ITEM 5.1 (c)

85 Harrington Street
The Rocks
GOLDEN AGE & HANNAS THE ROCKS

RESPONSE TO DoPE
ITEM 5.1 (c)

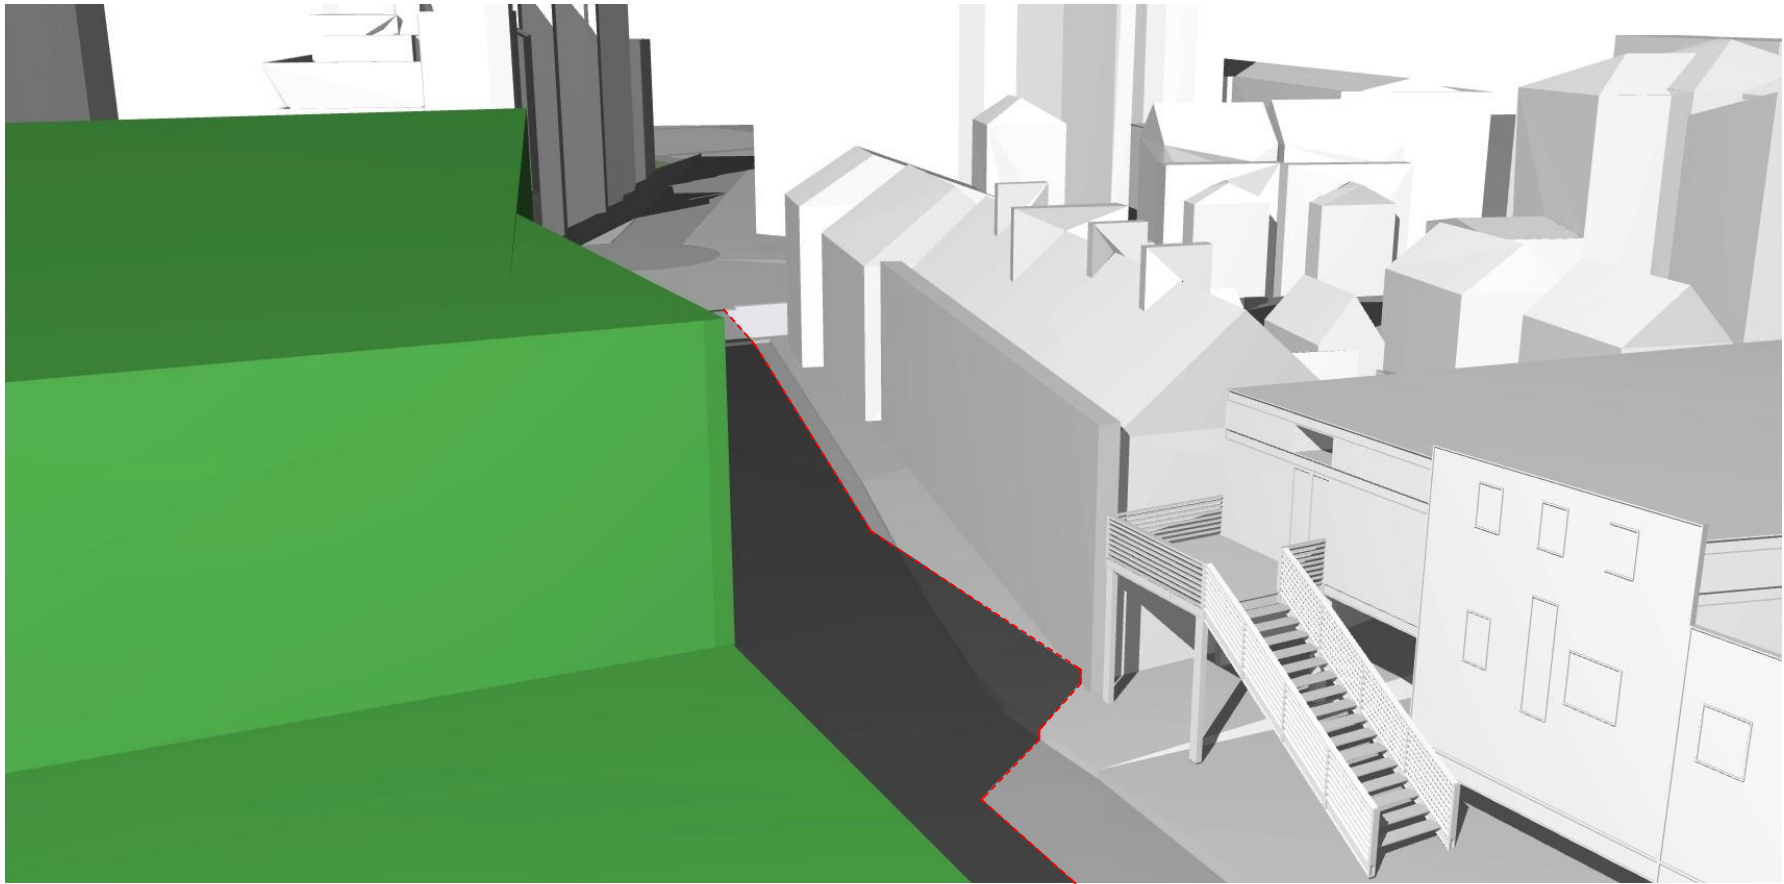
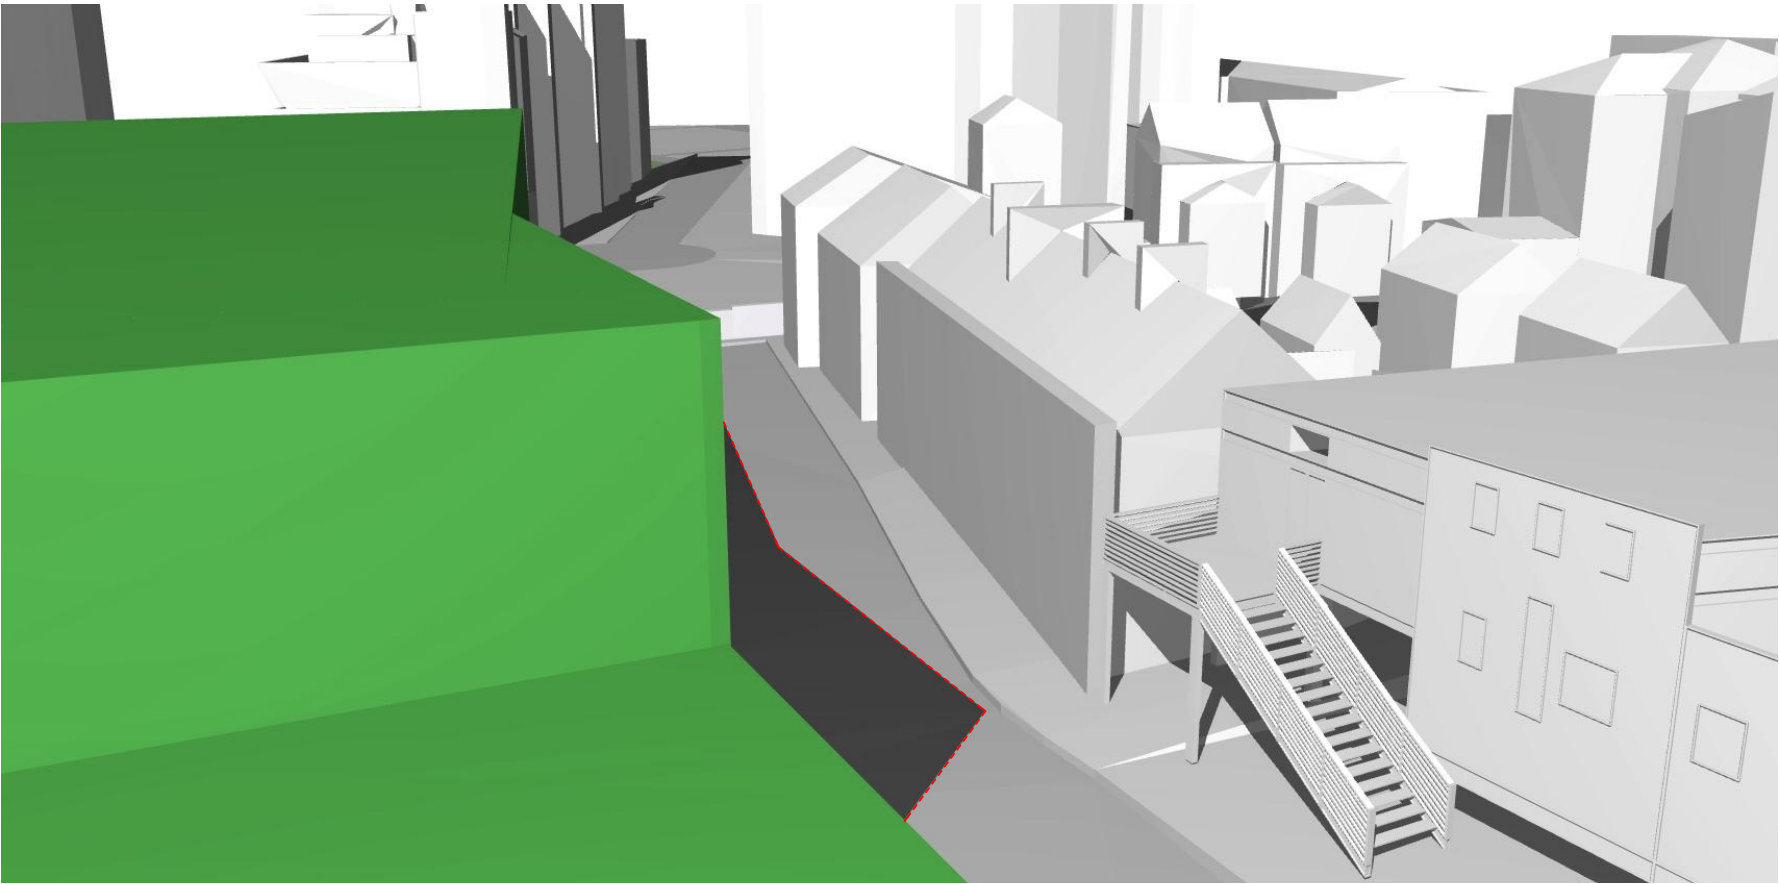
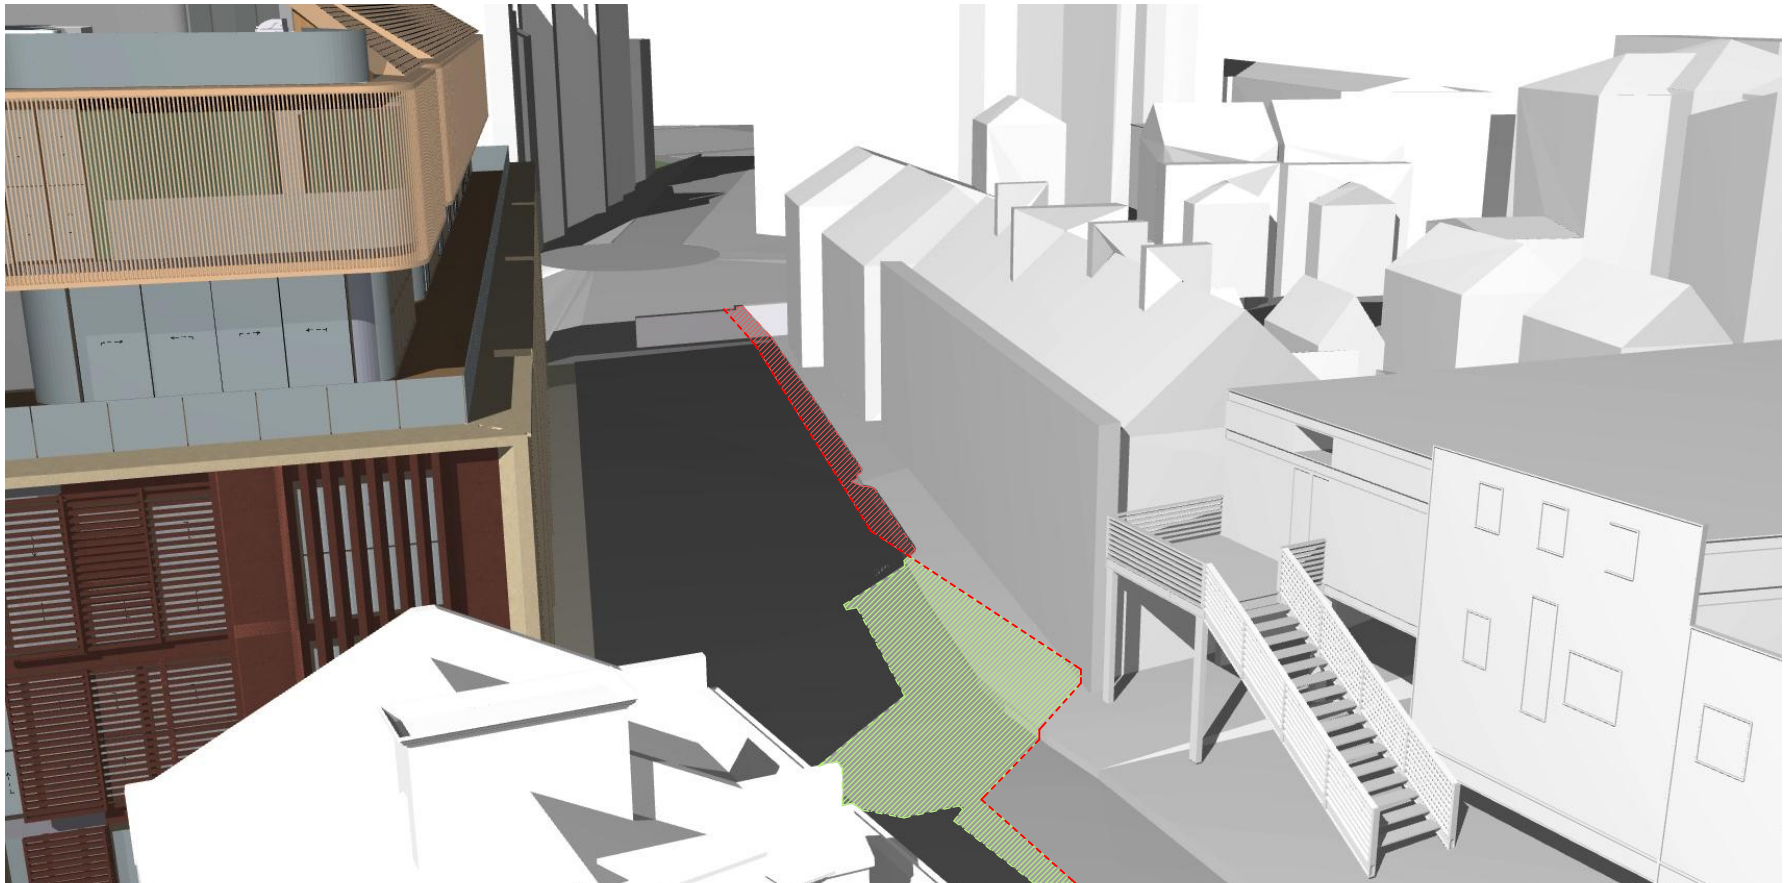
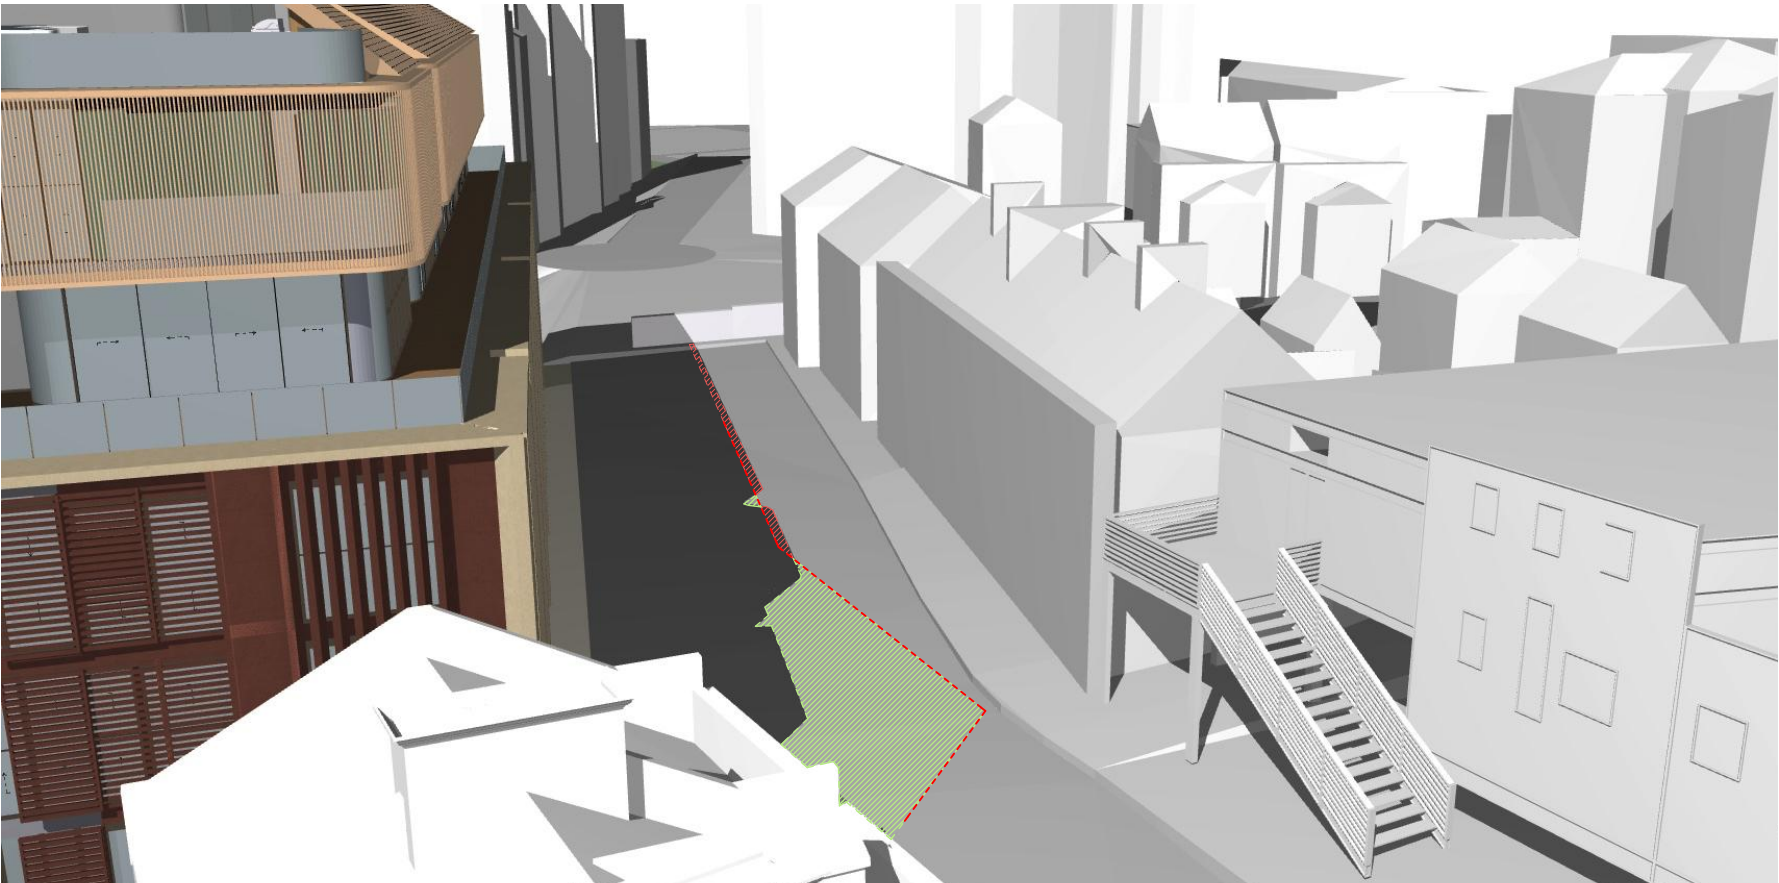
Issue/ Objection:
Solar Impact/
Overshadowing

Description:
Revised and enlarged 9am mid-winter elevational shadow diagrams clearly illustrating the extent of overshadowing compared to a SCRA compliant scheme. 9:30am diagrams should be provided if any shadow increase to neighbouring properties in Gloucester Street will occur at 9am

Response
Revised diagrams have been provided showing overshadowing impacts for Gloucester Street. These have been provided at both 9am and 9:30am for both March, June, September 21. The analysis concludes that the development largely improves on a SCRA compliant scheme.

- Notes:**
- Minor increase in shadow outside of SCRA envelope extent at 9am
 - No additional shadow cast on Gloucester terraces at 9:30am
 - Full solar access to Gloucester Terraces at 9:30am
